CITY OF CHARLOTTESVILLE

To: City of Charlottesville Planning Commission  
CC: Alex Ikefuna, Director  
Missy Creasy, Assistant Director  
Lisa Robertson, Chief Deputy City Attorney  
From: Brian Haluska, Principal Planner  
Date: October 8, 2019  
Re: Form-Based Code Draft for Phase 1 of the Strategic Investment Area

To: Alex Ikefuna, Director  
CC: Missy Creasy, Assistant Director  
Lisa Robertson, Chief Deputy City Attorney  
From: Brian Haluska, Principal Planner  
Date: September 24, 2019  
Re: Public Feedback on the SIA Form-Based Code Draft

**Figure 6.3 Height Illustrated**

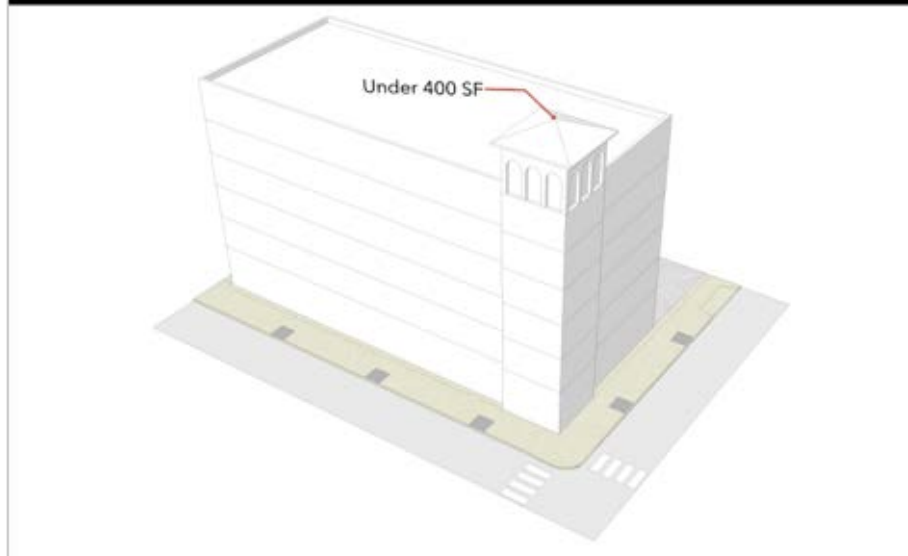
70. *Section 6.* Minimum ground floor heights are referenced but not stated. They are shown as 16’ in figure 6.1. If this is the set minimum, it should also be listed in the text. Does this apply to the T4 transect as well?

71. In figure 6.1, is the 4-5’ dimension between the residential floor slab and the sidewalk elevation an absolute? This may preclude multi-family buildings on sloping sites. How does ADA access work for these units from a shared lobby? Does this figure apply to the T4 transect – if someone wants to build townhouses for instance?
